Original first floor rear windows
1:50

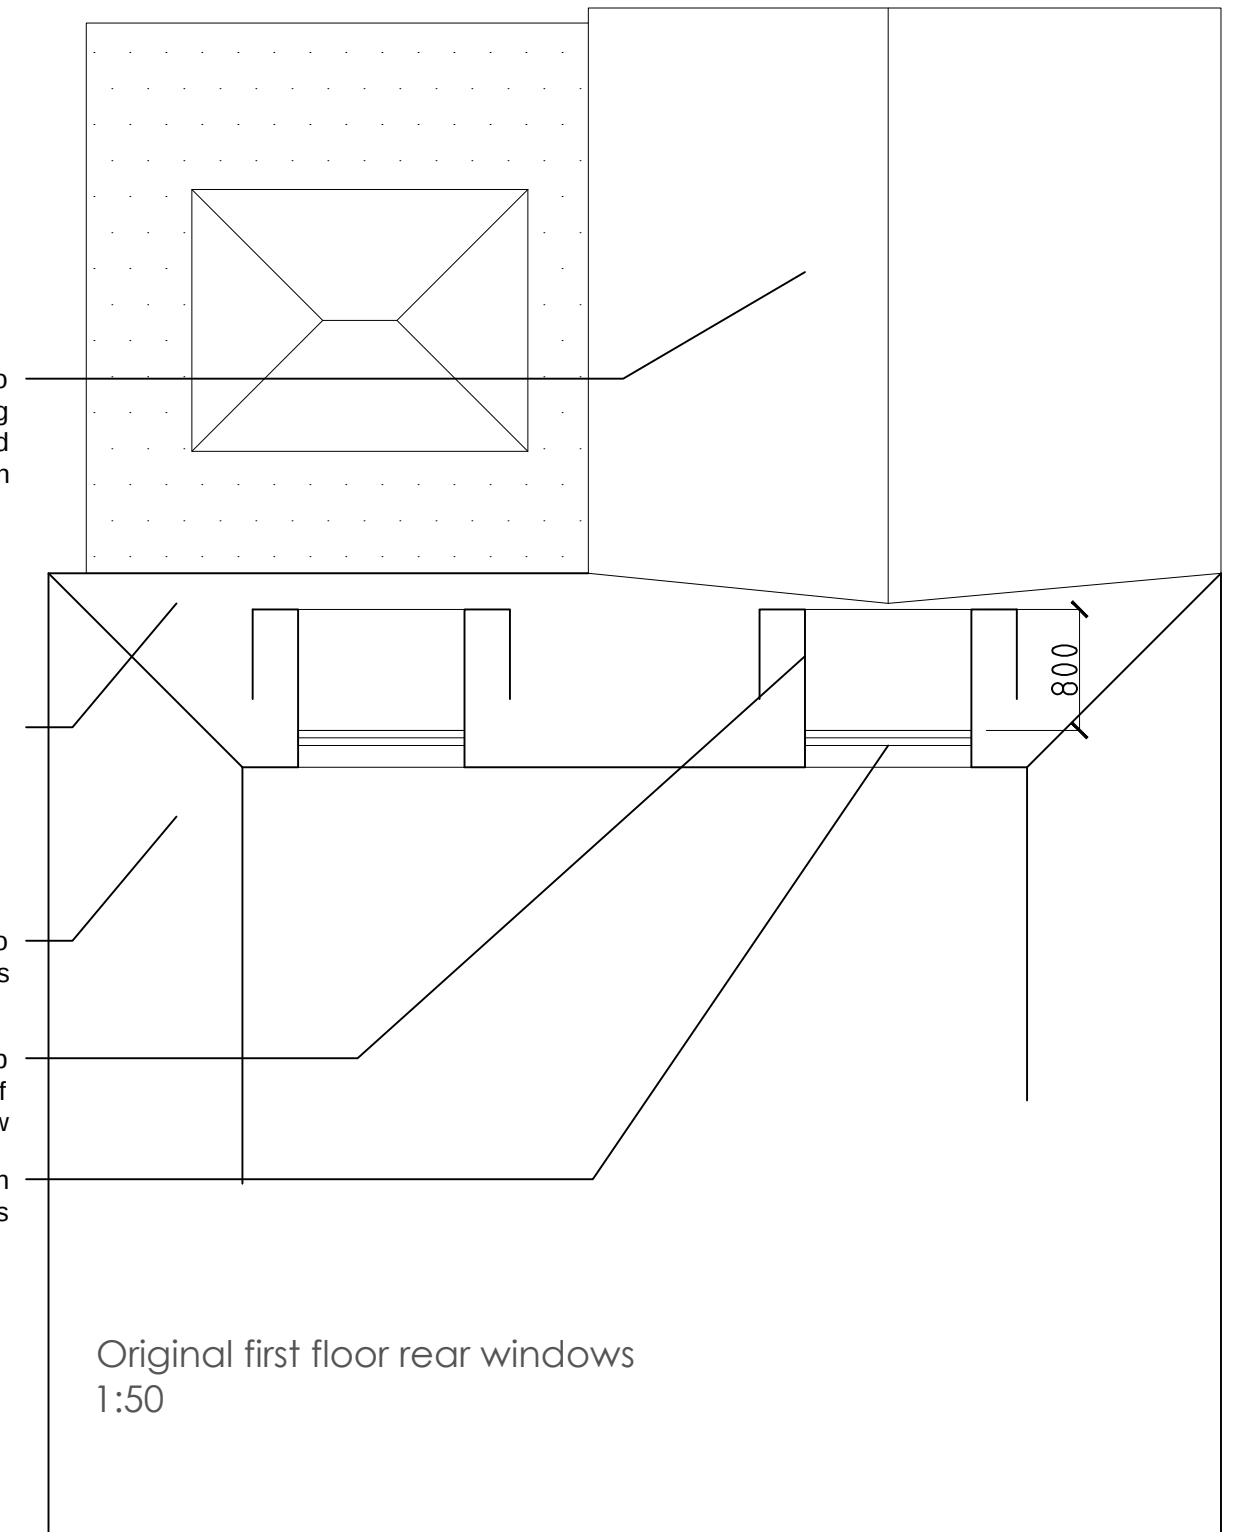
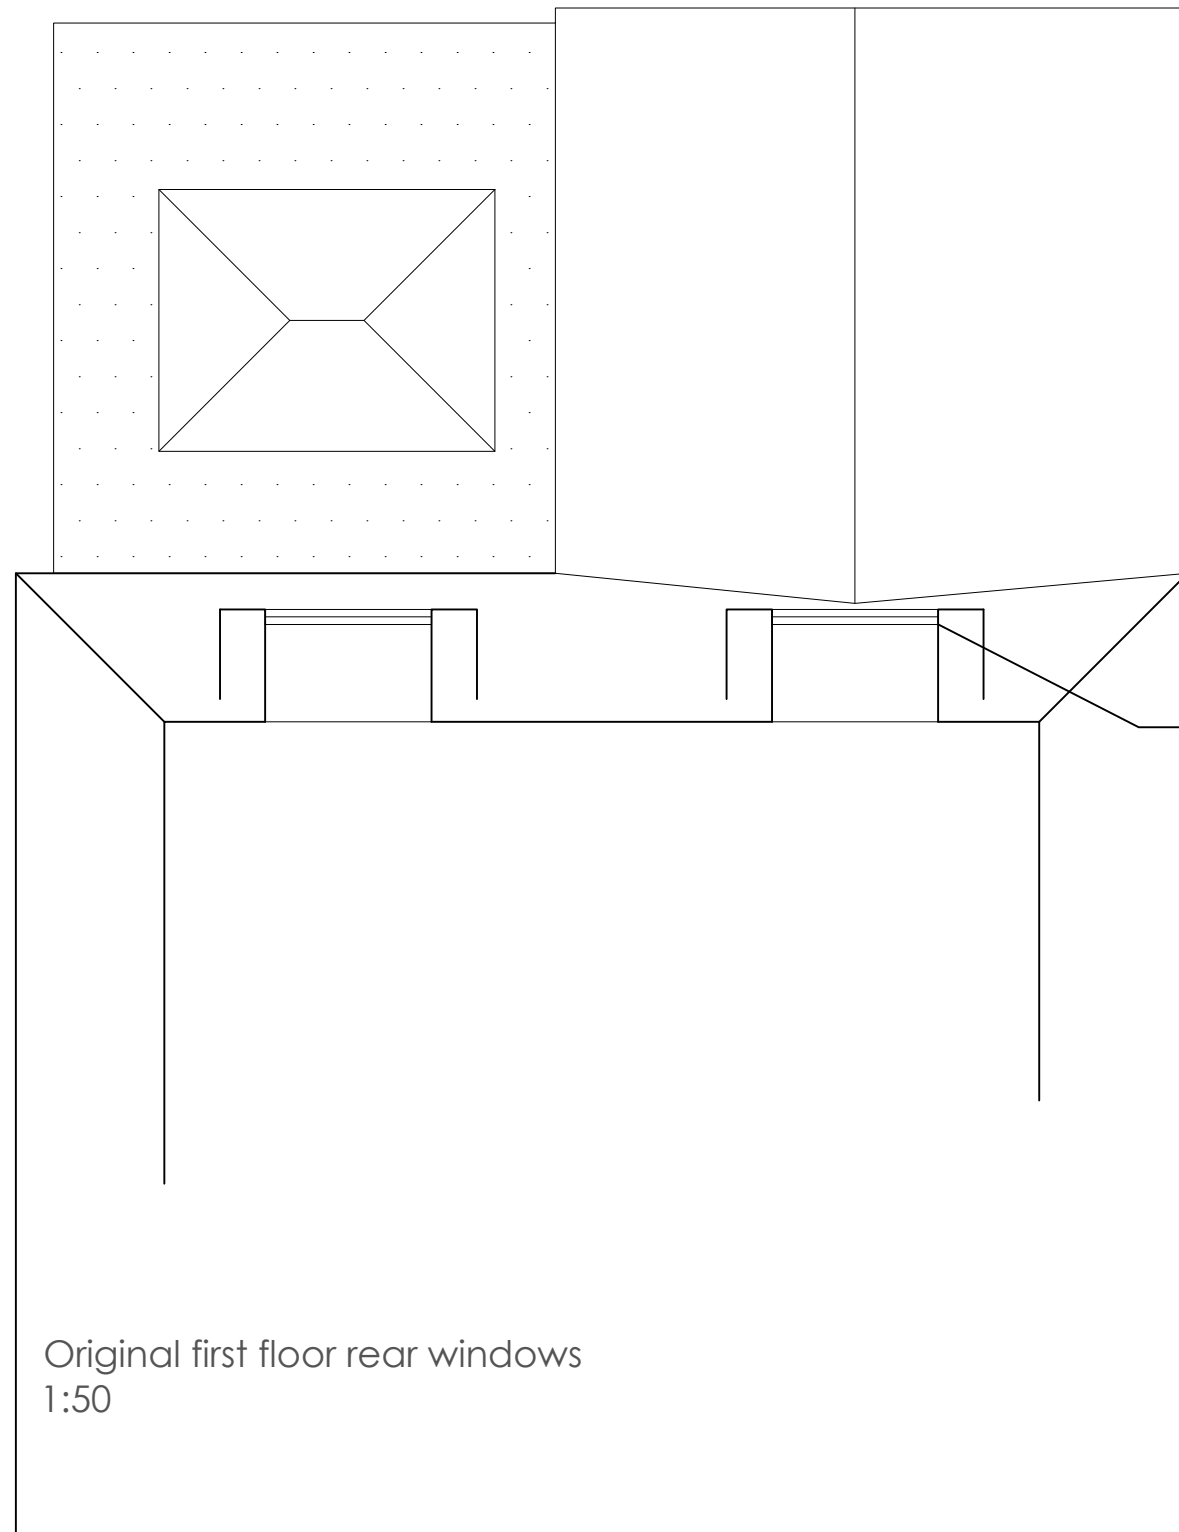
View from proposed rear windows also reduced by having to look over existing single storey rear extension pitched roof and lantern

Original window position

Roof pitch reduced from 75 degrees to 65 degrees

Window setback create 800mm deep full height privacy screening to sides of window

Window set back 800mm in dormer/pop out reveals
